Ward The Ferry

Formation of Entrance Gate in North Boundary Wall and Path to House

The formation of an Entrance Gate is **RECOMMENDED FOR APPROVAL subject to conditions.** Report by Director of Planning and Transportation.

Application No 08/00859/FUL

Proposed Garden Gate in Seafield Road

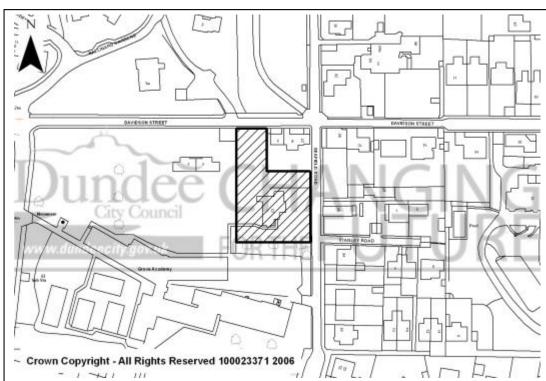
Broughty Ferry Community Council has objected to the proposals on the grounds that planning permission has already been granted for the formation of a vehicular access in the eastern boundary wall with the formation of an additional pedestrian access in the northern boundary wall (at a considerable distance from the house) being unnecessary and damaging to the integrity of the wall.

Broughty Ferry Community Council has expressed concern that the proposed pedestrian access through the B listed northern boundary wall of Avrom House would damage the integrity of the wall. Furthermore, as a vehicle access has already been granted permission by virtue of planning application 07/00927/COU there is no need for further access to the property.

As detailed in the assessment of the proposals against the criteria of Policy 55 (Urban Design), Policy 60 (Alterations to Listed Buildings) and Policv 61 (Development in Conservation Areas) the proposed access is of a scale, massing and design that compliments the character and setting of both the B listed mansion house and walls as well as the historic Davidson Street streetscape. Not only this, but the proposed access will enhance the connectivity of the application site with the local area.

The concerns of Broughty Ferry Community Council are not supported.
